# PAKLAY HYDROPOWER PROJECT

## 5<sup>th</sup> MRC Regional Stakeholder Forum

20 September 2018

### Mean Monthly Discharges at Damsite from 1960 to 2015

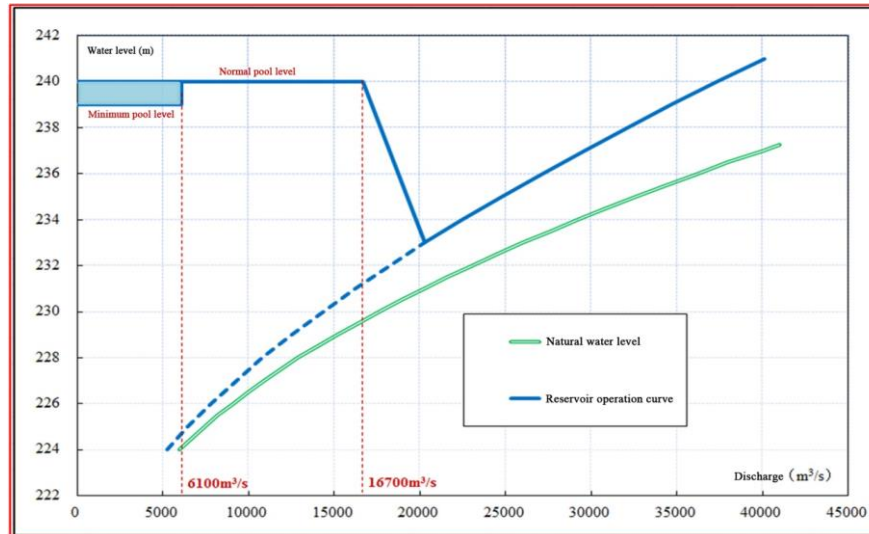
**CNR Review Comment:** The runoff and flood should be checked.

**Modification:**

- b) The runoff at the damsite has been analyzed and checked based on the damsite measurements and the processed data and the collected data;

### 2.2.1 Basic Information and the Suspended Load Sediment at the Dam site

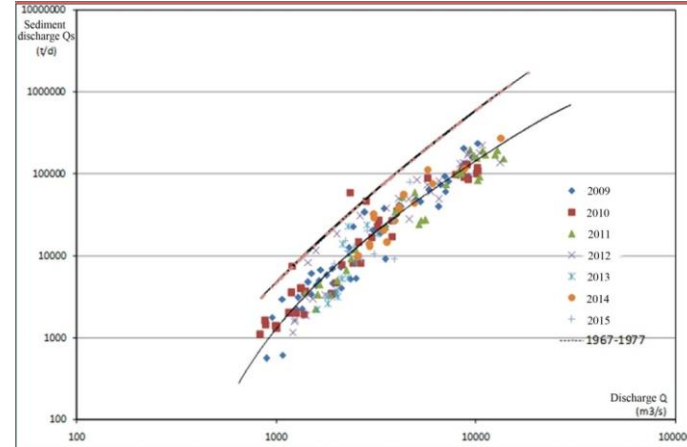
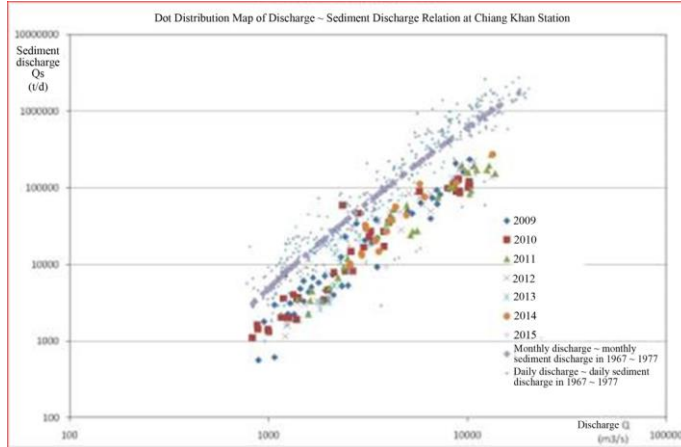
**CNR Review Comment:** Additional basic information should be collected and the suspended load sediment results should be checked at the dam site.

**Modification:**

- a) The sediment data were additionally collected.
- b) The suspended load sediment results at the dam site were analyzed and calculated;
- c) The sediment results were checked and reviewed.

### 2.3.4 Integral Model Test for Construction Diversion

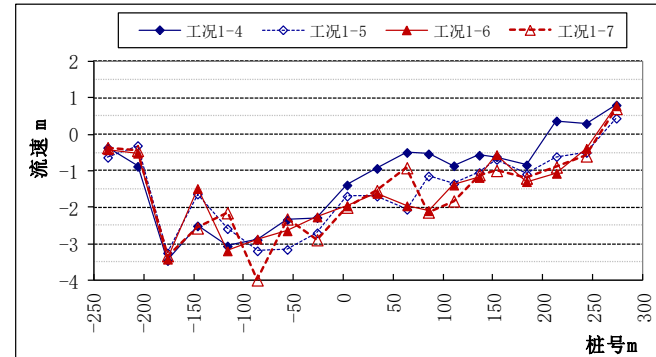
**CNR Review Comment:** It is suggested to add integral model test for construction diversion.

**Modification:** The model test shows that the construction diversion layout can meet the design requirements and the navigation during construction .

Pictures and Results of Model Test for Stage I Construction Diversion:

### 2.3.5 Adjustment in Seismic Design Standard

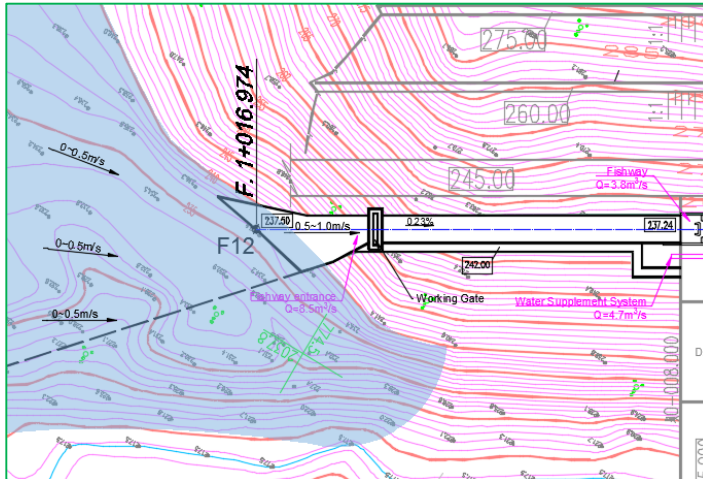
**CNR Review Comment:** Considered earthquakes should be clarified and unified throughout feasibility study (MCE, OBE, SEE). No table of seismic parameters is given.

**Modification:** The seismic hazard assessment of Paklay HPP is conducted by a third party, the peak ground acceleration is 0.384 g for 100-year exceeding probability of 2%.

Layout of Downstream Entrance

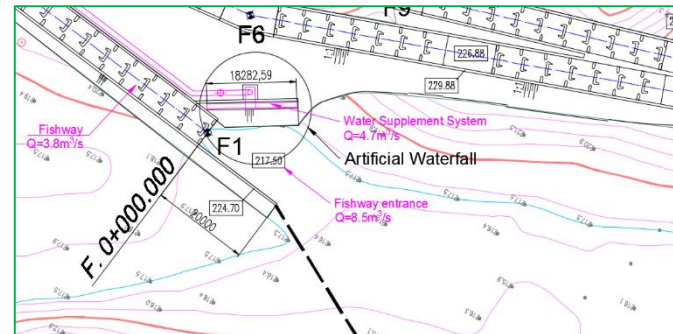
**Brazilian Experts' Review Comment:** The downstream entrance of the fish way should be connected with the bottom of the riverbed.

**Modification:** The layout of the upstream and downstream entrances of the fish way has been modified. The water flow at the upstream entrance is gentle, and the change of water flow at the fish way entrance can help the fishes find the entrance.

The downstream entrance is arranged about 270m downstream of the powerhouse at the bank, where the riverbed is flat and the conditions for fish guiding are favorable.

### 2.5.2 Large Resting Pool

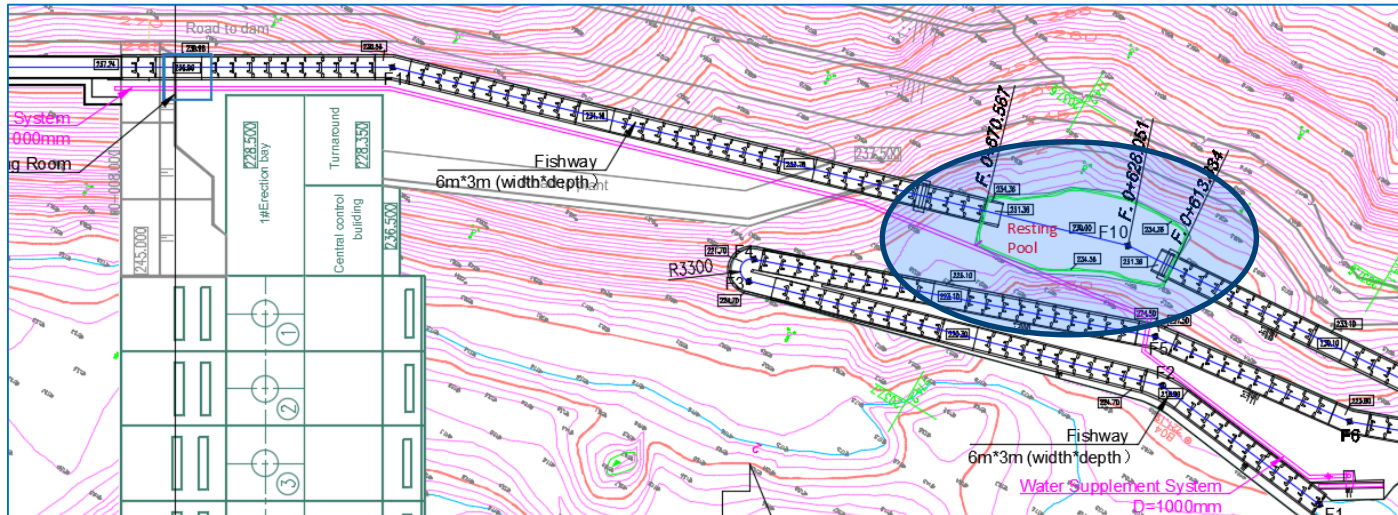
**Brazilian Experts' Review Comment:** A large resting pool should be added.

**Modification:** A large resting pool (about 56m long, 22m wide and 4.5m deep) has been added in the middle section of fishway, where the fishes can take a rest and find food so as to have energy to swim upstream.
